Access Compliance Report

Public Rights-of-Way

(Curb Ramps)

Intersection ID: 3749	Main Street: FOUNTAINGROVE_DR	Cross Street: PRIORY_CT	Location: S
ADA ID: CD8024BFE083	Ramp Type: Perp	Initial Pass/Fail: Fail	Overall Compliance: No
Codes/Mitigation Info/Possible Solution		Field Measurements/Component Compliance	
Severity Score: 18.75

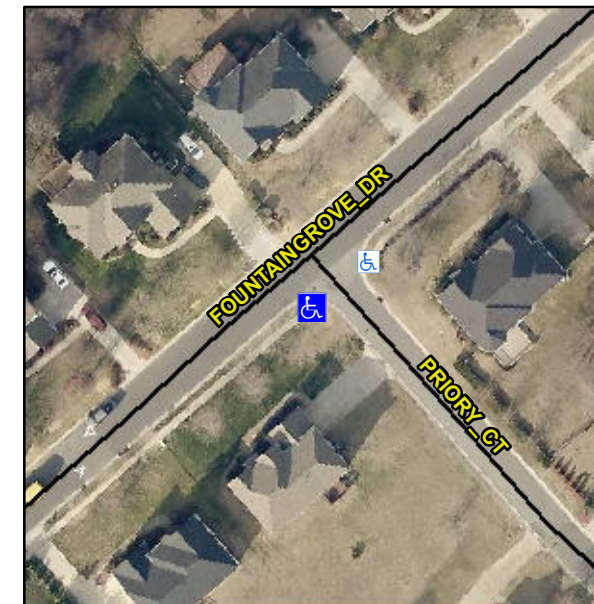
Not Found, R304.5.1, R304.5.3

Compliance	Description	Data	Compliance	Description	Data
N/A	Ramp Length (in)	46.0	Yes	Ramp Slope (%)	6.3
No	Ramp Width (in)	34.0	No	Ramp XSlope (%)	3.9
N/A	Flare Type LT	N/A	N/A	Flare Type RT	N/A
N/A	Flare Slope LT (%)	N/A	N/A	Flare Slope RT (%)	N/A
N/A	Flare Traversable LT?	N/A	N/A	Flare Traversable RT?	N/A
N/A	Landing Length (in)	N/A	N/A	DWS Provided?	N/A
N/A	Landing Width (in)	N/A	N/A	DWS Contrast?	N/A
N/A	Landing Slope (%)	N/A	N/A	DWS Length (in)	N/A
N/A	Landing X Slope (%)	N/A	N/A	DWS Full Width?	N/A
N/A	Landing Curb? (Y/N)	N/A	N/A	DWS Offset (in)	N/A
N/A	Shared Landing?	N/A			
N/A	Gutter Ponding?	N/A	N/A	Gutter Slope (%)	N/A
N/A	Gutter Lip Ht (in)	N/A	N/A	Gutter X Slope (%)	N/A
N/A	Painted X Walk1?	No	N/A	Painted X Walk2?	N/A
	X Walk 1 Direction	To NE		X Walk 2 Direction	N/A
N/A	X Walk 1 Width (in)	N/A	N/A	X Walk 2 Width (in)	N/A
	X Walk 1 Slope (%)	4.1		X Walk 2 Slope (%)	N/A
	X Walk 1 X Slope (%)	2.2		X Walk 2 X Slope (%)	N/A

Remove & Replace Entire Ramp.
